HOMEWOOD SUITES JSP14-31

Consideration at the request of Stellar Hospitality, LLC for approval of the Preliminary Site Plan and Stormwater Management Plan. The subject property is located in Section 14, north of 11 Mile Road and east of Town Center Drive in the OSC, Office Service Commercial District. The current submittal, Homewood Suites, includes a five story extended stay hotel with 88 rooms along with associated parking, loading and landscape on 1.87 acres of the total site.

In the matter of Homewood Suites, JSP 14-31, motion to **approve** the Preliminary Site Plan based on and subject to the following:

PLANNING REVIEW

SITE PLAN

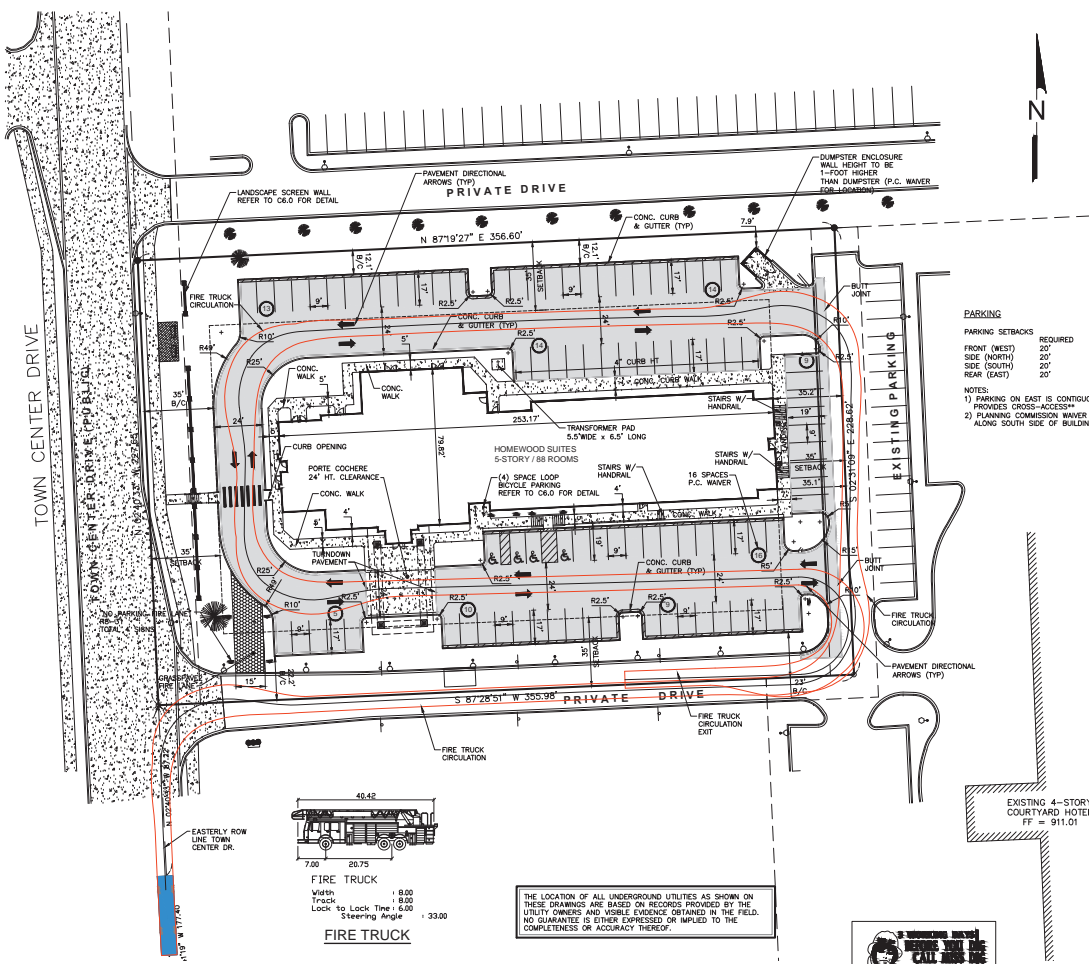
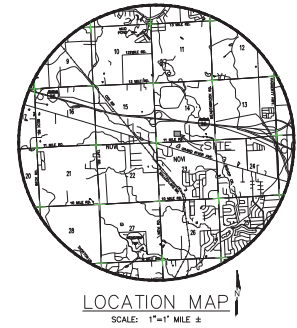
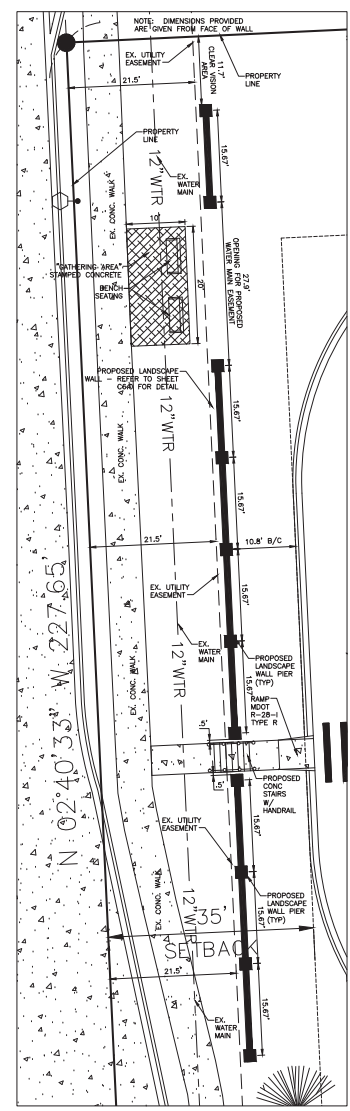
- e) Zoning Board of Appeals variance from Section 3.1.23.D of City Zoning Ordinance to reduce the minimum parking setbacks; (Side setback on North: required 20 ft. , provided approx. 10 ft. and rear setback on East: required 20 ft., provided approx. 6 ft.)

- a) Zoning Board of Appeals variance from Section 5.4.1 of City Zoning Ordinance to not provide a loading space;
- b) Zoning Board of Appeals variance from Section 4.19.2.F.iv of City Zoning Ordinance to allow a corner of the dumpster to be located within parking setbacks;

- c) Increase the width of the Emergency access to twenty feet as indicated in the response letter;
- d) The findings of compliance with Ordinance standards in the staff and consultant review letters and the conditions and the items listed in those letters being addressed on the Final Site Plan; and

- a. Directional arrow pavement markings have been added to sheet C3.0 and detailed on sheet C6.0.
- b. The applicant has indicated where the handicap parking signs shall be located within the site; however, the van accessible parking signing is not compliant, as follows:
 - i. The applicant should consider installing an R7-8 sign as well as an R6-7P sign in front of the van accessible space, instead of just the R7-8P sign as indicated on the plan.
 - ii. The applicant should update the Traffic Control Sign Table on sheet C3.0 to include four (4) R7-8 signs.

1. Variances will be requested for the reduction in the parking setbacks and has been so noted on sheet C3.0. Submission has been made to the ZBA.
2. A Planning Commission waiver is being requested for the proposed 16 spaces of parking on the south side of the hotel. We have included landscape islands at each end of this bank of parking.

1. The width of the secondary access for public safety has been increased in width to 20-feet from the prior 15-feet indicated on the plan.
2. Mountable curb will be utilized along the proposed drive on the hotel property to allow for ease of access. Notation for the location has been indicated on sheet C3.0.
